Model: Model PG-C1	Date: 12-May-06	No.: RB229001b
--------------------	-----------------	----------------

Subject: Firmware Release History (System)		Prepared by: A.Ishiyama	
From: 1st Tech. Support Sec. Service Support Dept.			
Classification:	<input type="checkbox"/> Troubleshooting <input type="checkbox"/> Mechanical <input type="checkbox"/> Paper path <input checked="" type="checkbox"/> Other (      )	<input type="checkbox"/> Part information <input type="checkbox"/> Electrical <input type="checkbox"/> Transmit/receive	<input type="checkbox"/> Action required <input type="checkbox"/> Service manual revision <input type="checkbox"/> Retrofit information

Model: Pegasus-C1	Date: 24-Nov-06	No.: RB229020a
-------------------	-----------------	----------------

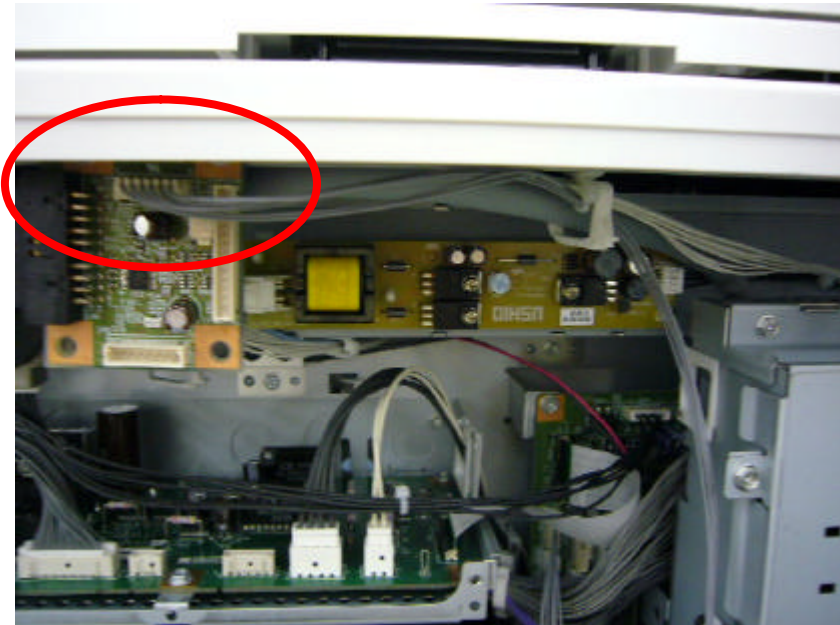
3. ***Connect the harness between CN3 on the key counter interface board and CN149 on the BCU board.***

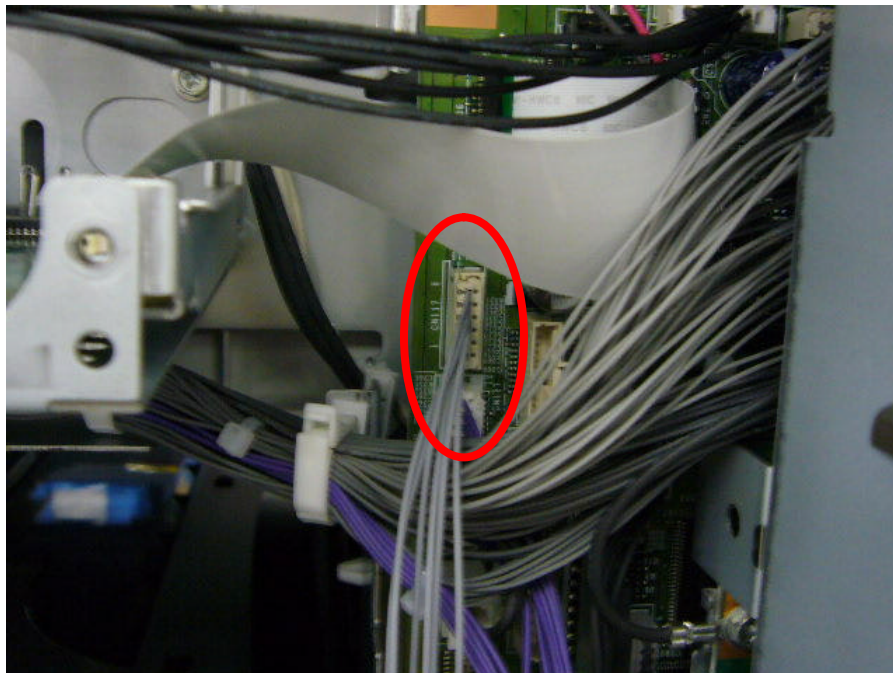
3. Connect one end of the harness to the key counter interface board.

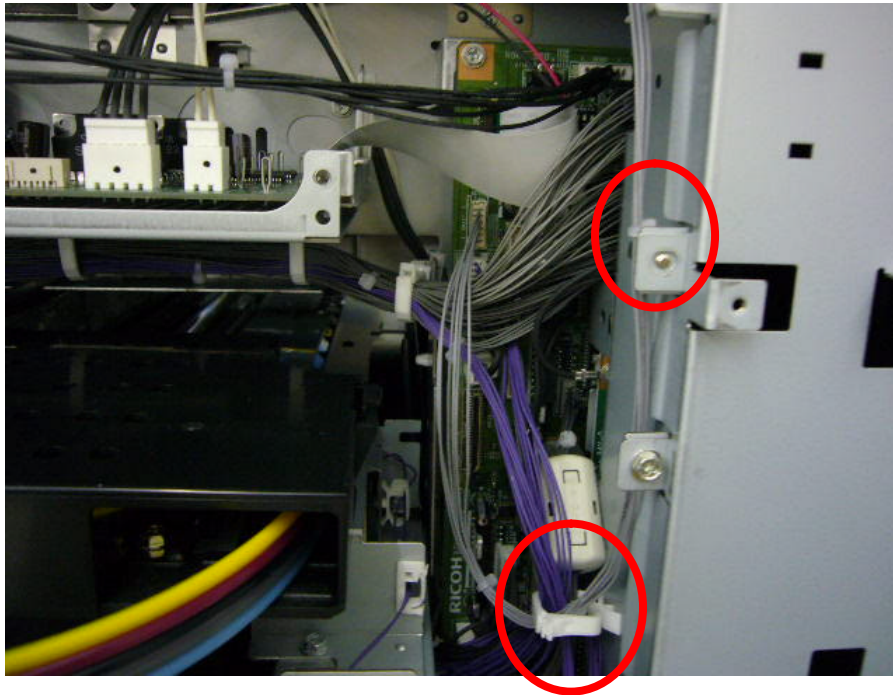
4. Connect the other end of the harness to **CN117** on the BCU.

5. Route and clamp the harness as shown.

No.: RB229024

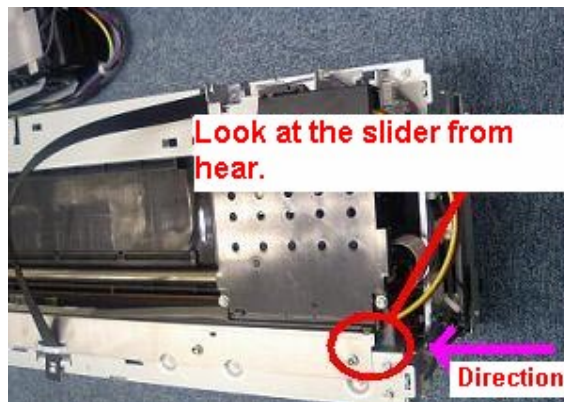
To fix the carriage unit in place more securely, the packaging for the unit will be changed and shipping tape will be added to the carriage unit.

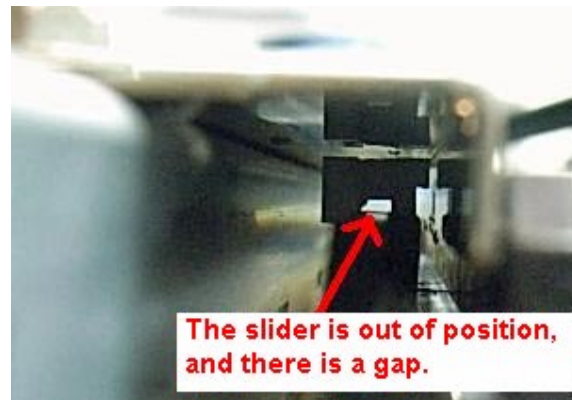
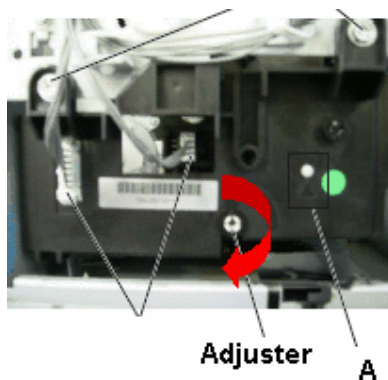
**If the carriage slider is in the “incorrect” position shown in the following photo, do Steps 3–5.**

Correct position

**Incorrect position**

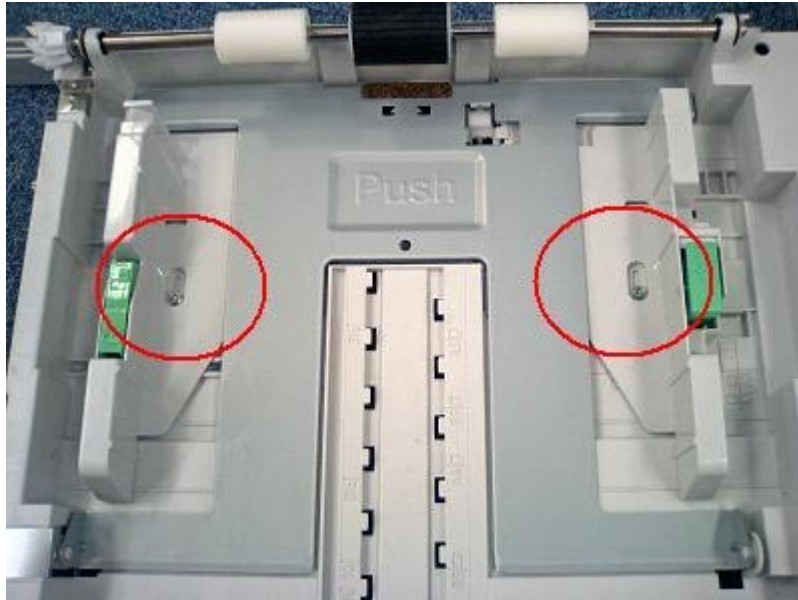
Entrance jams occur frequently.

The operator does not fit the side fences to the size of the paper loaded in the cassette.

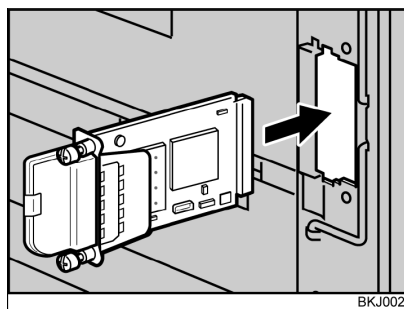
Previous types:  
PCB, LAN card, and cover are  
separate

New Type (IEEE802.11b  
Interface Unit Type N):  
Pre-assembled

## B2295808: Harness:Entrance Senor

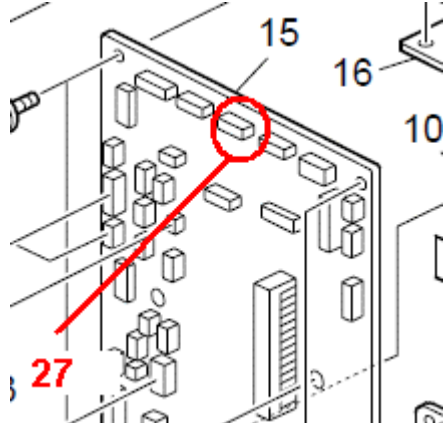
**Change/Reason:** This part was missing from the Parts Catalog.

Old part number	New part number	Description	Q'ty	Int	Page	Index	Note
-	B2291918	Set Sensor Board:Cartridge:B229	1		29	12

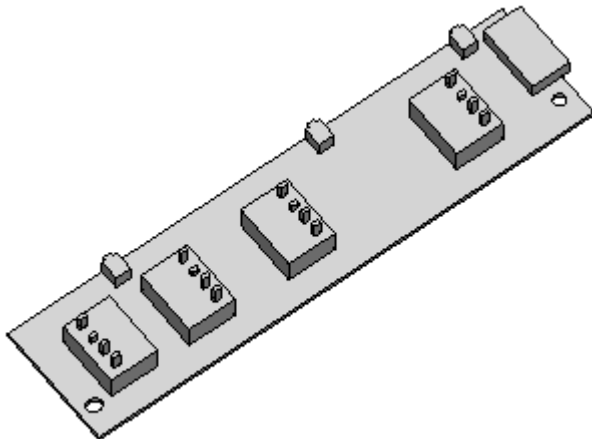
**Change/Reason:** This part was missing from the Parts Catalog.
